Date 12.09.03	Ref. No. AU02802R1	Model CDP-SP55, HCD-CP101, HCD-CP300, HCD-CP500MD, HCD-DX10, HCD-DX20, HCD-DX30, HCD-DX90, HCD-J300, HCD-M10, HCD-M70, HCD-RG20, HCD-RG22, HCD-RG33, HCD-RG55S, HCD-RG66, HCD-TB10, HCD-VP100, HCD-VX222, HCD-VX333	HA
Subject Different CD Playback Problems [REVISION 1]			IRIS 1551

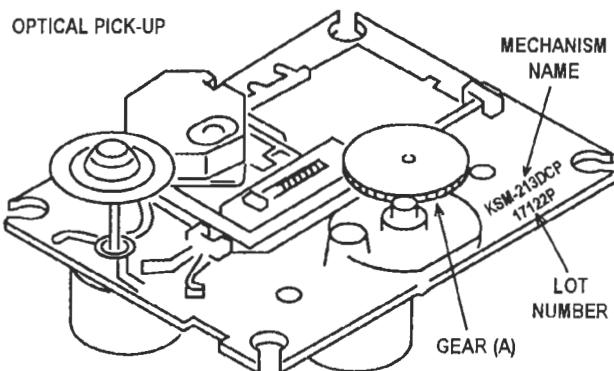
The diameter of the axis of the part "Gear (A)" is too small so that the rack of the optical pick-up does not engage with the gear.

Replace the part "Gear (A)" (2-626-907-02) with the improved type **2-626-907-11**.
